# RENESAS TECHNICAL UPDATE

Product Category	MPU/MCU		Document No.	TN-RZ*-A0113B/E	Rev.	2.00
Title	RZ/G1H, G1M, G1N and G1E Correction of section 15. External Bus Controller for DDR3-SDRAM (DBSC3)		Information Category	Technical Notification		
Applicable Product	RZ/G Series, RZ/G1H, RZ/G1M, RZ/G1N, RZ/G1E	Lot No.	Reference Document	RZ/G Series, User's Manual: Hardware Rev.1.00 (R01UH0543EJ0100)		
		All lots

Document correction for section 15. External Bus Controller for DDR3-SDRAM (DBSC3).

**Figure 15.29 M0(/1)RESET# pin level during DDR power-up**

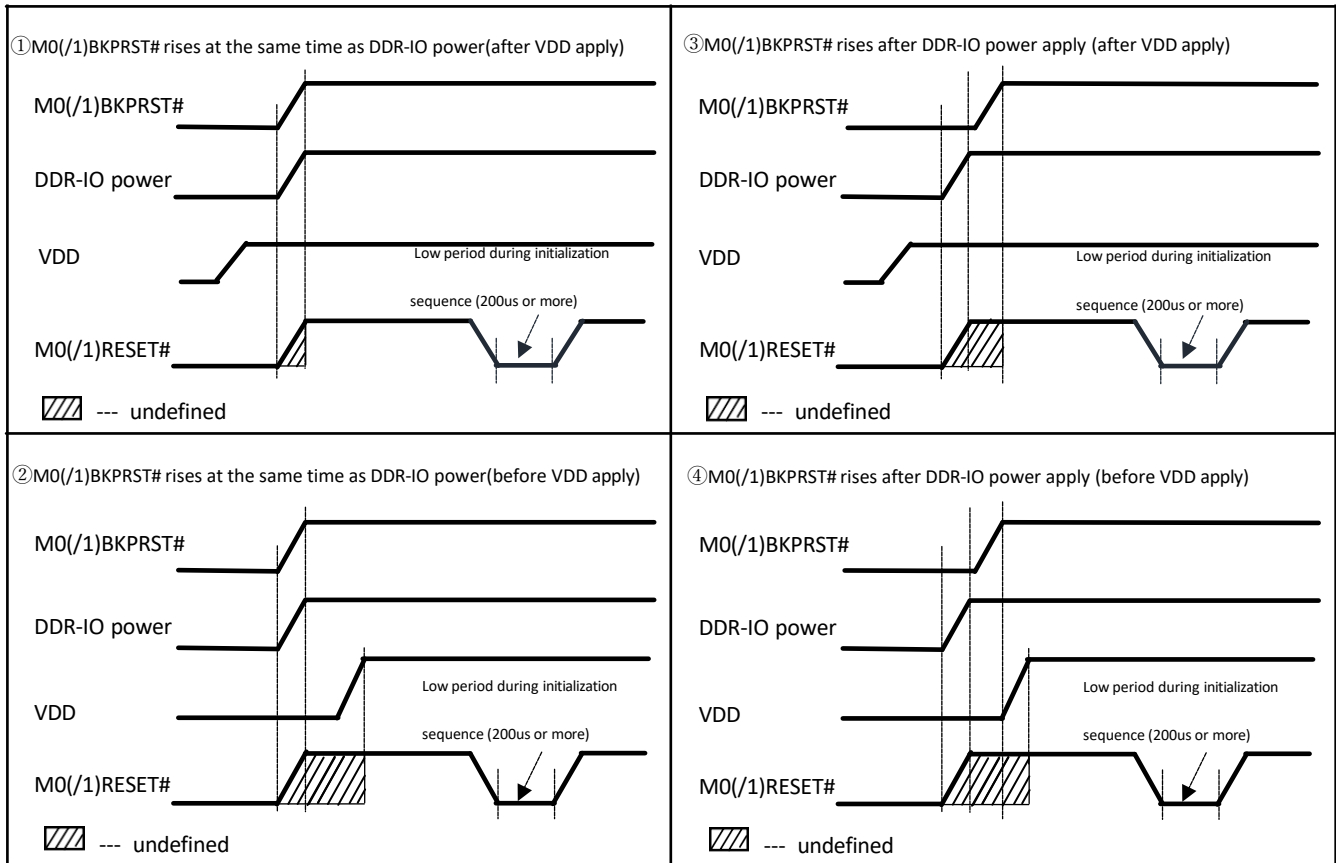
1. Section 15.8 M0(/1) RESET# pin level during DDR power-up, new section is added.

The pin level of M0(/1)RESET# is undefined during DDR power-up as shown in Figure 15.29

Caution for M0(/1)RESET# pin level during DDR power-up.

## EXPECTED ISSUE AND COUNTERMEASURES

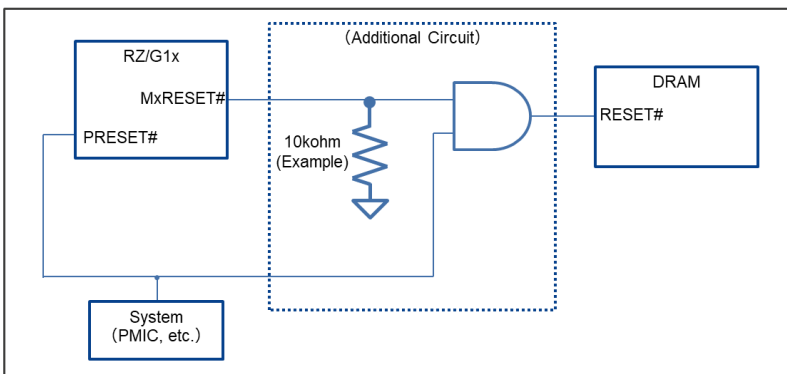
If RESET# is "H" at power-on, some DRAM products may not be initialized correctly.

In some DRAM products, initialization may not work as expected even if you try to initialize again with RESET# after the power has stabilized.

For this reason, with the RZ/G1x, it is necessary to add a circuit such as a pull-down resistor to set the initial state of the RESET# terminal to "L".

The 10kohm pull-down resistor will increase the VDDQ\_DDR current by up to 0.158mA (=1.575V(DDR3\_max)/10kohm).

## 想定される問題と対応策

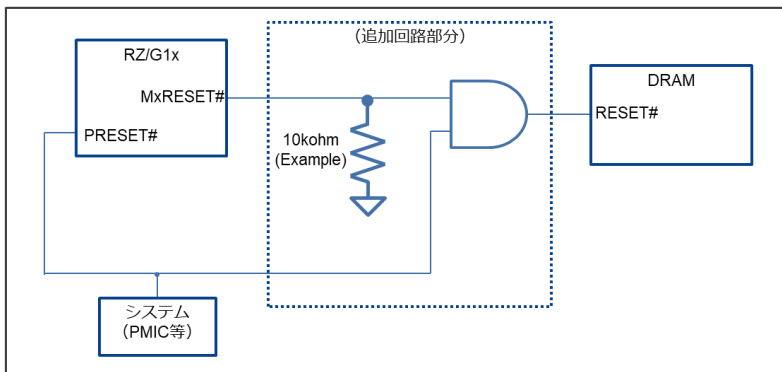
電源投入時、RESET#が“H”だった場合、一部のDRAM製品では正常に初期化されない可能性があります。

特に、一部のDRAM製品では、電源安定後に再度RESET#による初期化を行っても、初期化が期待通りに動作しない場合があります。そのため、RZ/G1xではPull-down抵抗等でRESET#端子の初期状態を“L”にするなどの回路付加が必要になります。

- 10kohmのプルダウン抵抗により、VDDQ\_DDRの電流は最大0.158mA (=1.575V(DDR3\_max)/10kohm) 増加します。
